ALERT SERVICE BULLETIN

NO. 430-01-21

**SUBJECT: UPPER FUEL ENCLOSURE, RIGHT SIDE,
ADDITION OF DRAIN PROVISION**

**HELICOPTERS AFFECTED: Model 430 helicopters serial number 49001
through 49079.**

FIGURE 1

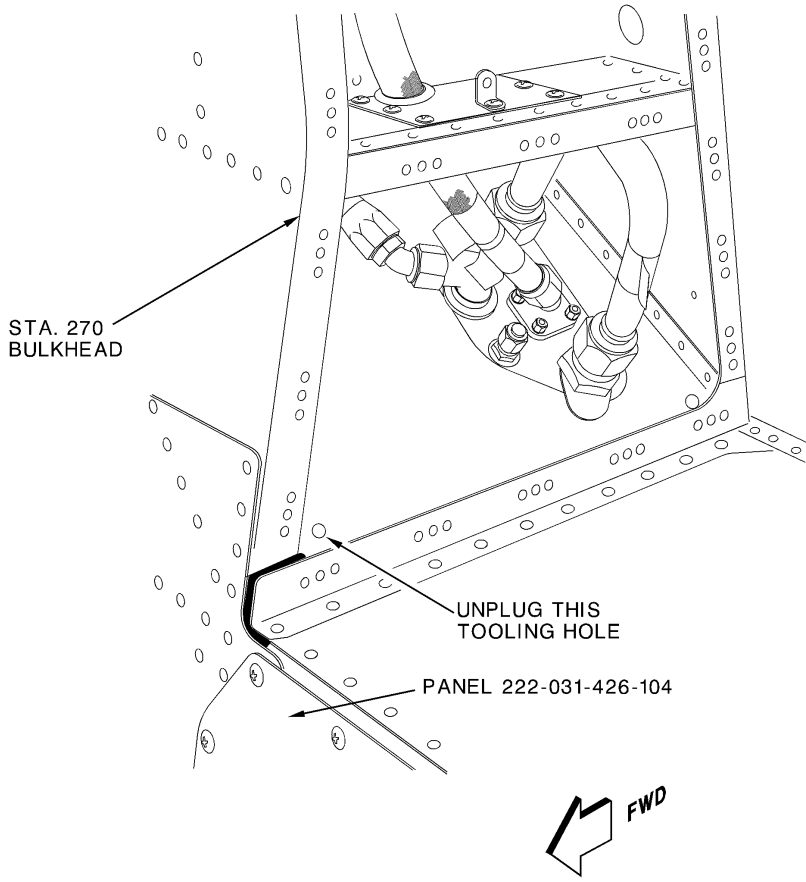
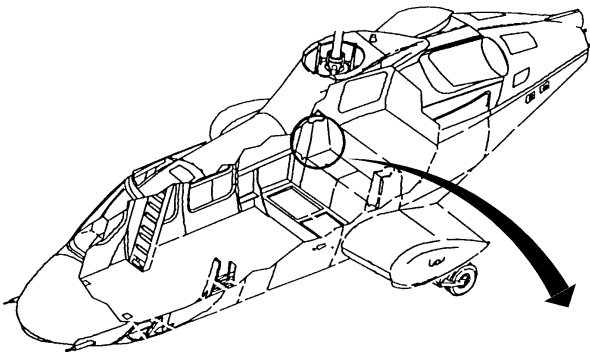
This bulletin provides the procedures to remove the sealant from the existing forward tooling hole located in panel assembly P/N 222-031-470-103 to provide enclosure drainage provision.

Tooling hole is located at approximate STA 271.00, B.L. 22.25, W.L. 54.00 in panel assembly P/N 222-031-470-103

5. Locate forward tooling hole in panel assembly P/N 222-031-470-103 and unplug hole using a plastic scrapper and a pin punch or a similar object. Refer to Figure 1.
6. Reposition fuel cell upper right hand side in airframe cavity.
7. Install access panel P/N 222-031-426-104 with sealant MIL-S-8784CLB2. Refer to BHT-430-MM-5, chapter 53.
8. Install the seat cushions and seat backs on the rear passenger seats. Refer to BHT-430-MM-3, chapter 25.
9. Annotate helicopter records to reflect compliance with this bulletin.
